W3F1-2004-0002

Subject: Waterford 3 SES
Docket No. 50-382
License No. NPF-38
Emergency Plan, Revision 30

**SUMMARY OF REVISION
WATERFORD 3 EMERGENCY PLAN
REVISION 30**

FIGURE 2-4

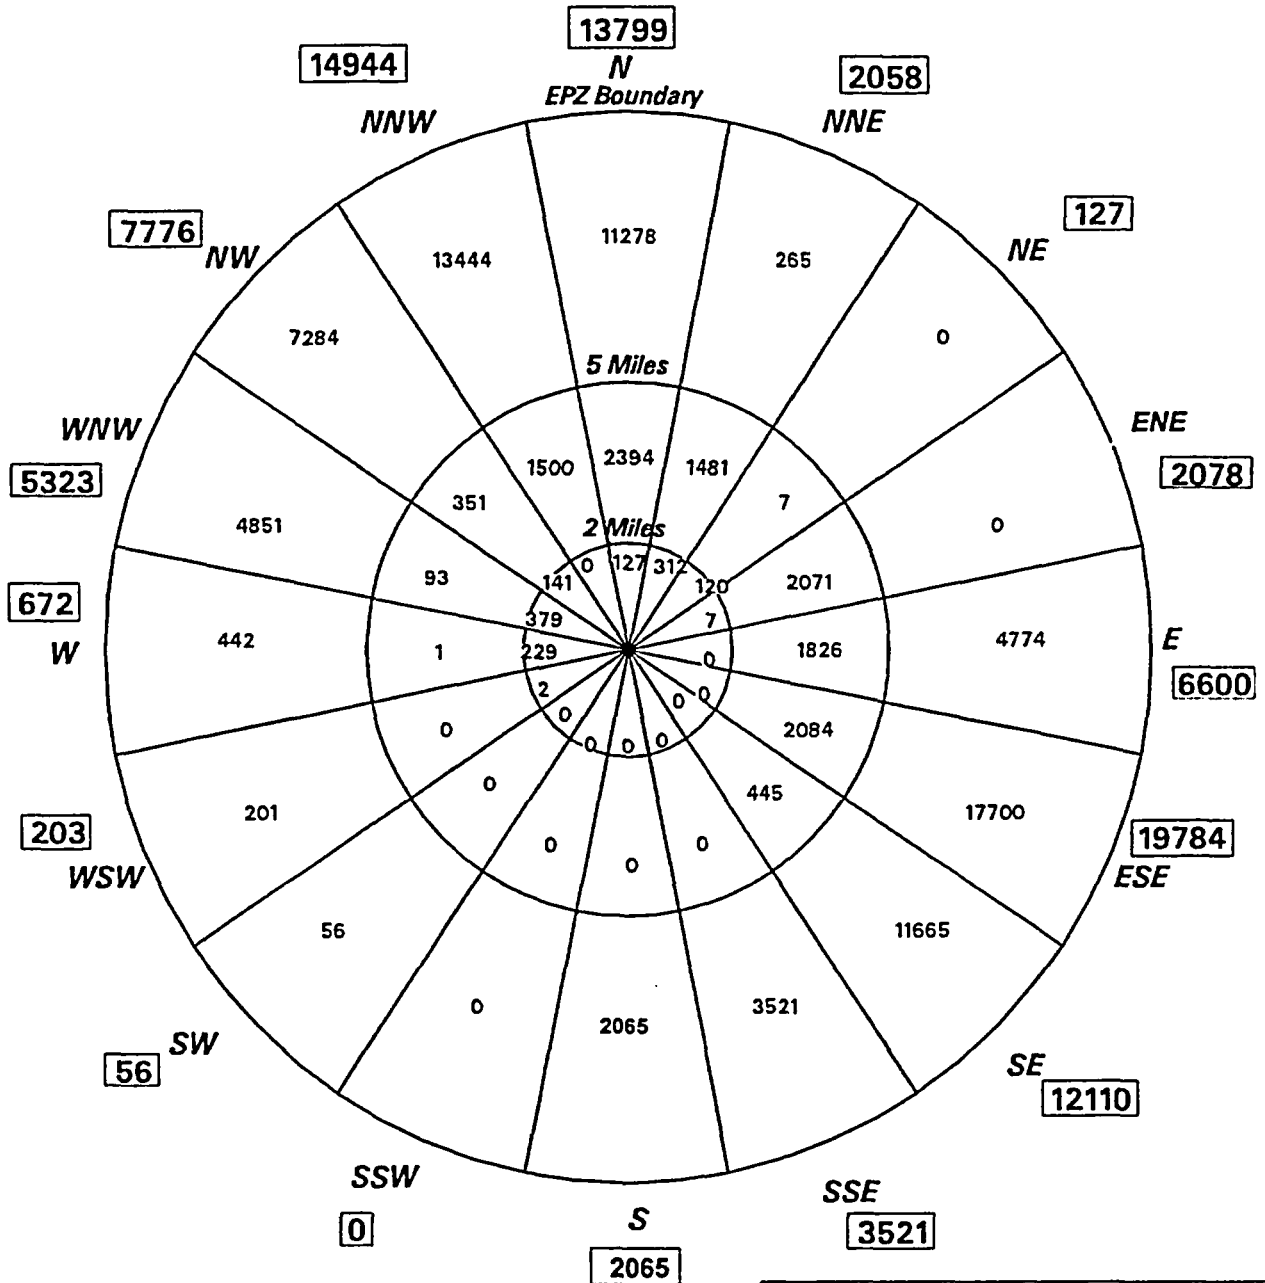
A-2-4	<p>Corrected identification of the ENE sector in Figure 2-4 for Permanent Residents Within 10 Mile EPZ. This sector was incorrectly identified in a previous revision of the Plan. This change is not considered a decrease in effectiveness since it accurately reflects the correct designation of population sectors within the 10 Mile EPZ.</p>
A-2-5	<p>Changed title of Figure 2-5 to "Permanent Residents Within 50 Mile EPZ" to more accurately reflect the information contained in the figure. This figure has been updated with 2000 census data, but otherwise the information is formatted similar to previous revisions of Figure 2-5. The updating of this information does not decrease the effectiveness of the Plan since it updates and more accurately reflects the number of residents located in the 50-mile Emergency Planning Zone around Waterford-3.</p>

W3SES EMERGENCY PLAN
FIGURE 2-5
PERMANENT RESIDENTS WITHIN 50 MILE EPZ

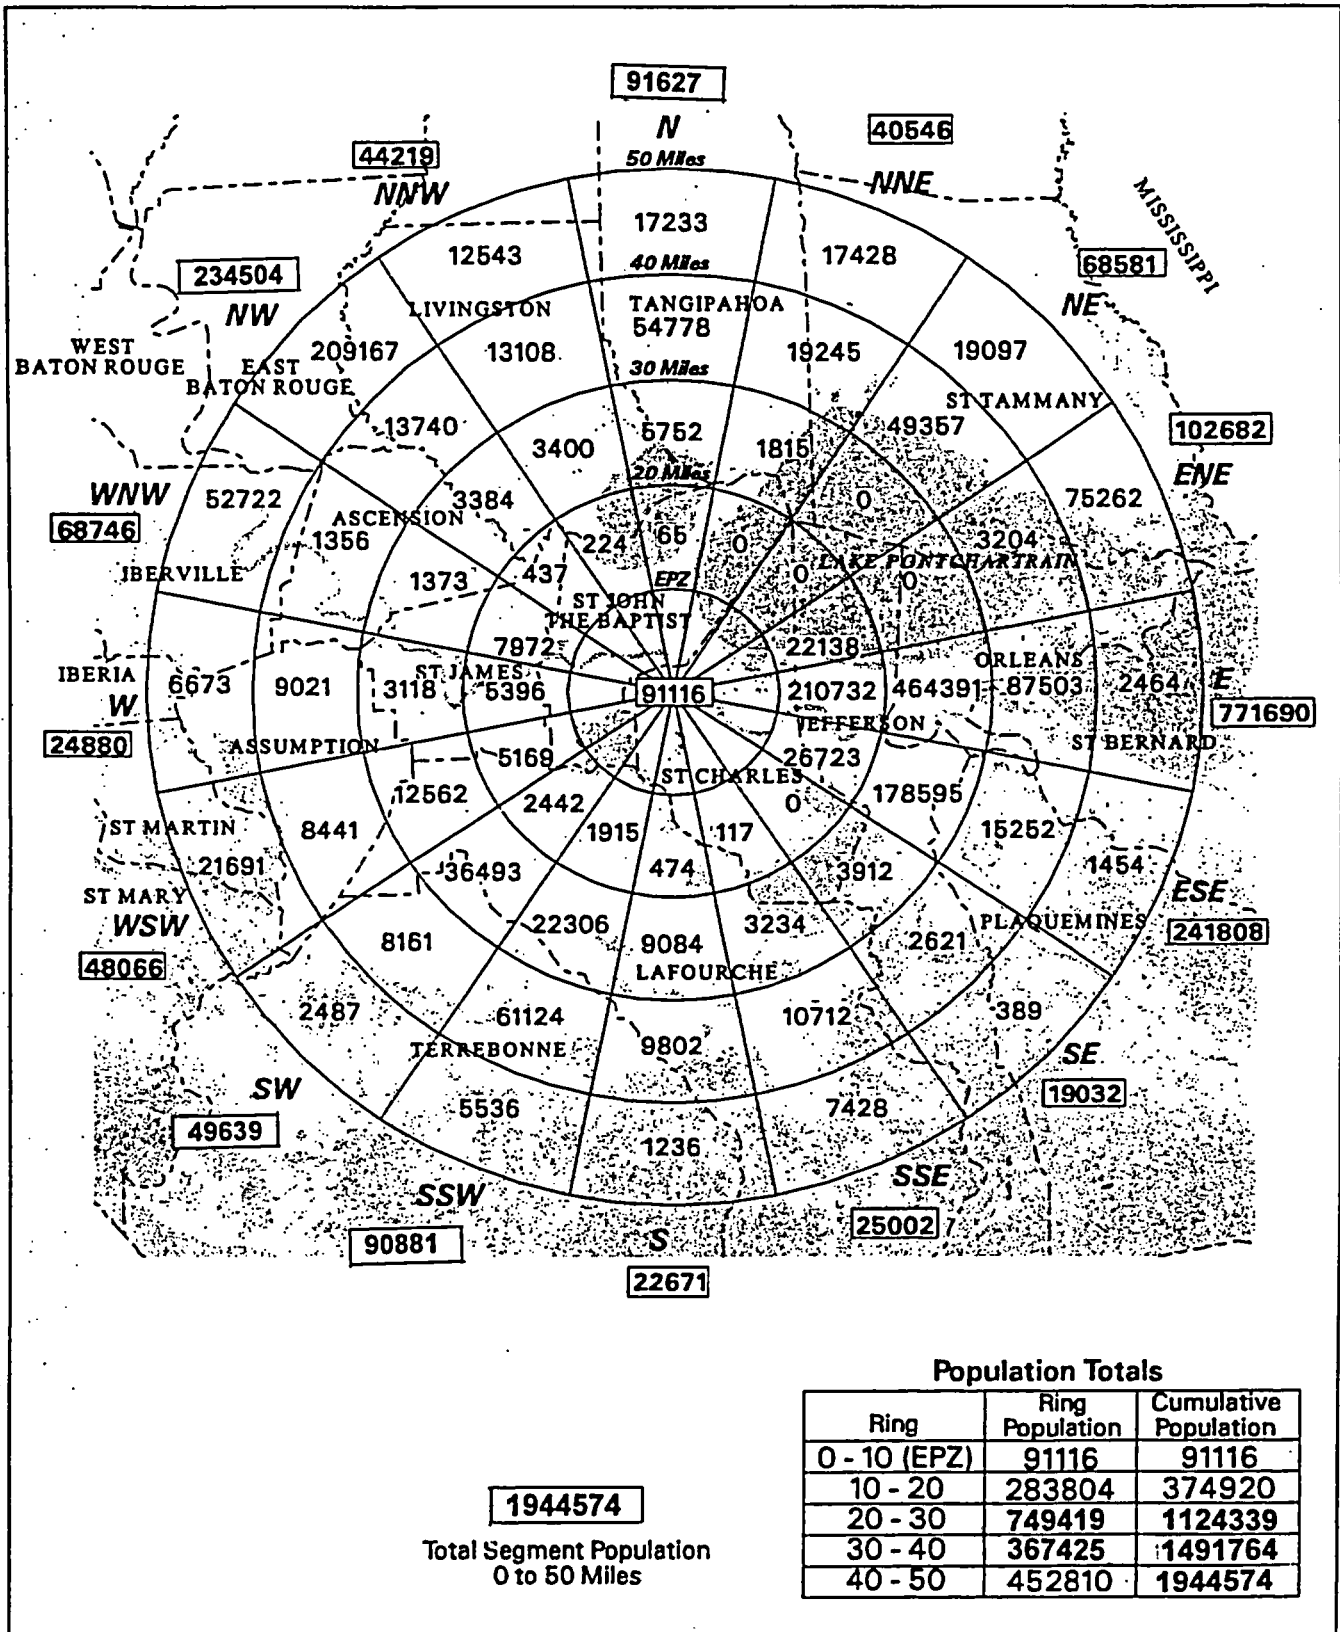
<u>PAGE</u>	<u>COMMENTS</u>
Various	Table of Contents was updated to reflect page numbers revised as part of this revision.
1	Changed title of Figure 2-5 from "Population Centers Within 50 Miles of Waterford 3" to "Permanent Residents Within 50 Mile EPZ" to reflect change in title of figure.
